UNITED STATES PATENT AND TRADEMARK OFFICE

APPLICATION NO.	FILING DATE	FIRST NAMED INVENTOR	ATTORNEY DOCKET NO.	CONFIRMATION NO.
10/055,757	01/22/2002	Rich Baranski	57111-5103	7325

Office Action Summary

DETAILED ACTION

Attachment #1

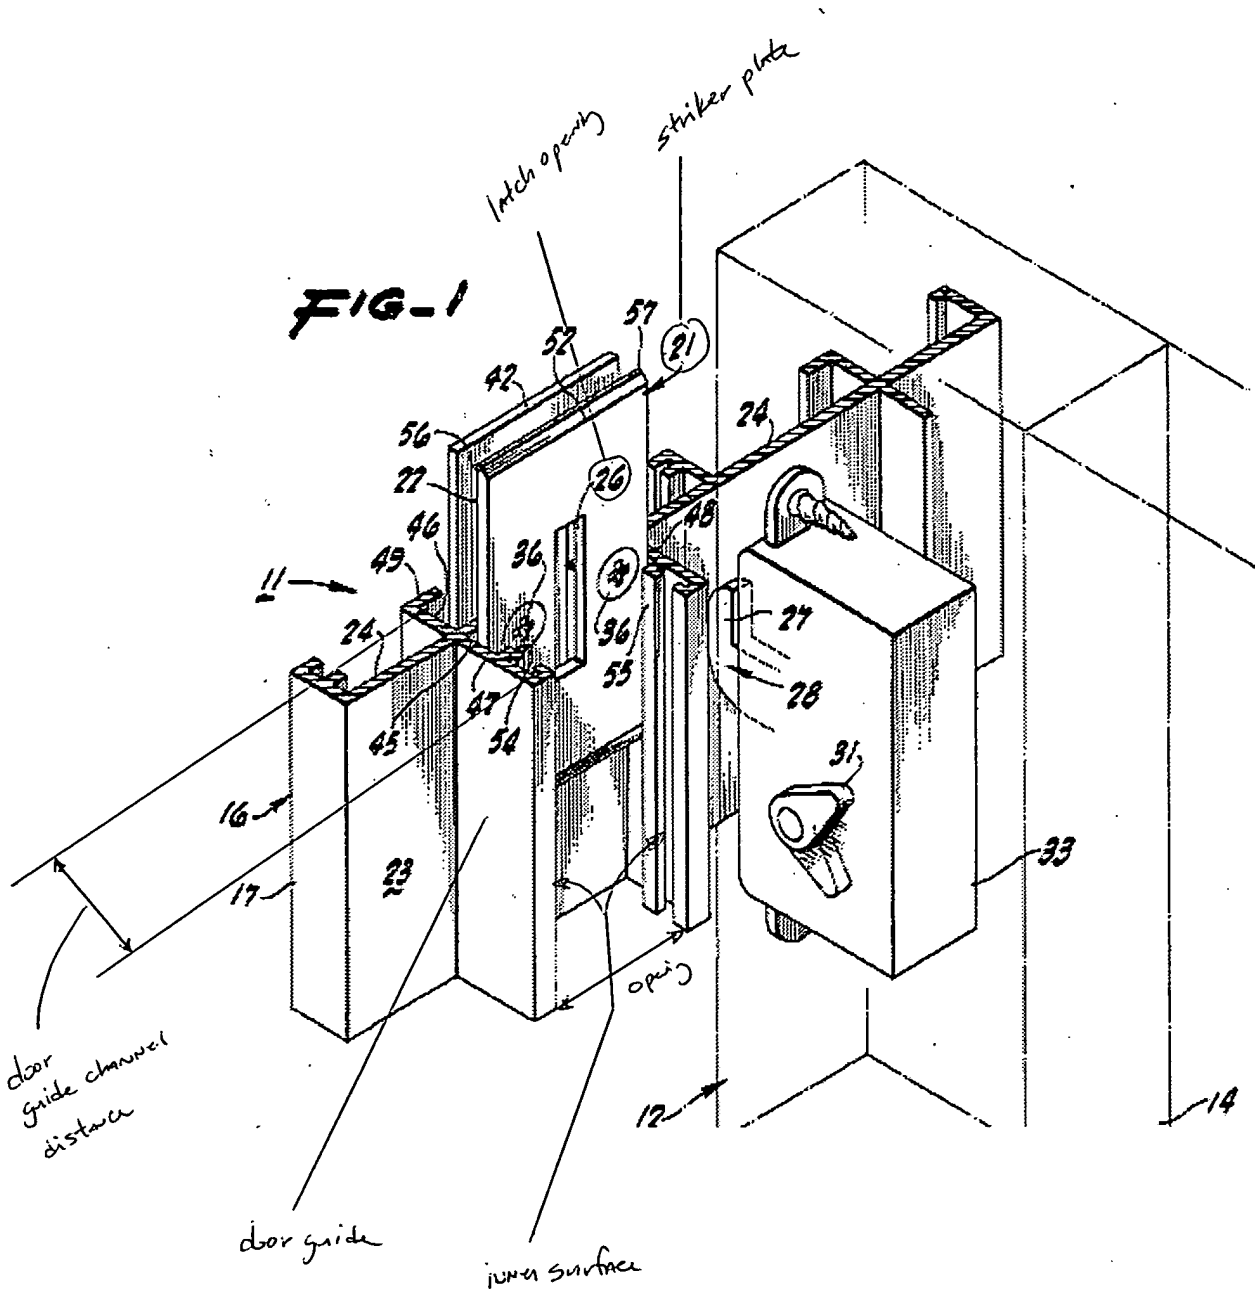
Regarding claims 1 and 20, Collier discloses an adjustable door guide latch slot assembly comprising a striker plate (21) having a latch opening (26), and a door guide (see attachment #1).

The door guide has a channel sized to retain a door slidably therein that includes an inner surface and an opening. The opening of the door guide is larger than the opening of the striker plate.

The striker plate may be adjustably affixed directly to the door guide inner surface so that the striker plate latch opening aligns with the latch of the door.

Attachment # 2

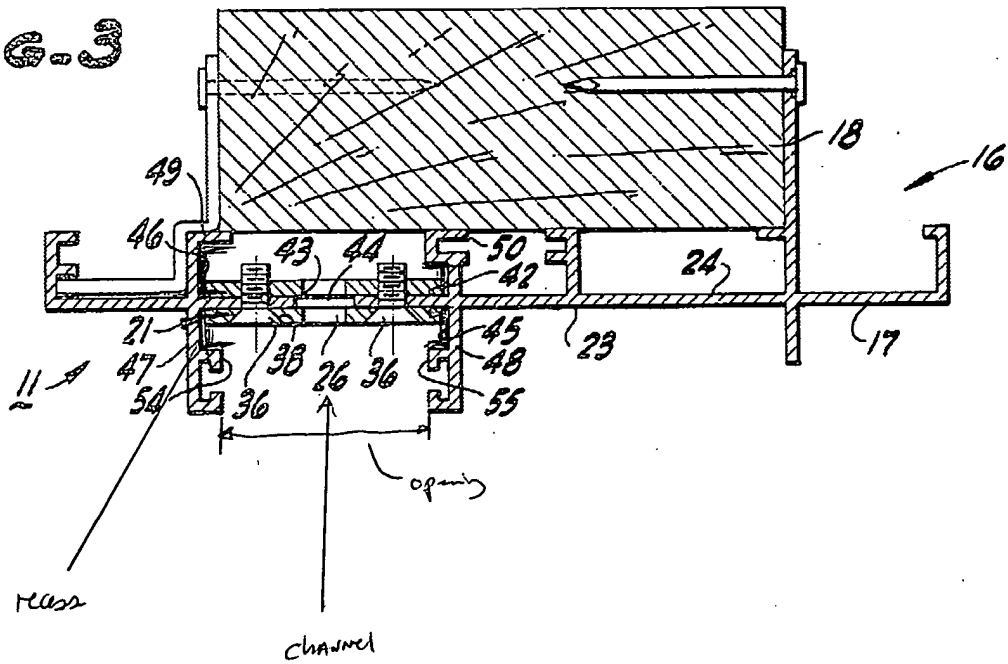
As to claims 3 and 15, Collier illustrates that the depth of the recessed area is at least as great as the thickness of the striker plate (see attachment #2)

As to claim 20, Collier illustrates that the depth of the recessed area is at least as great as the thickness of the striker plate (see attachment #2)
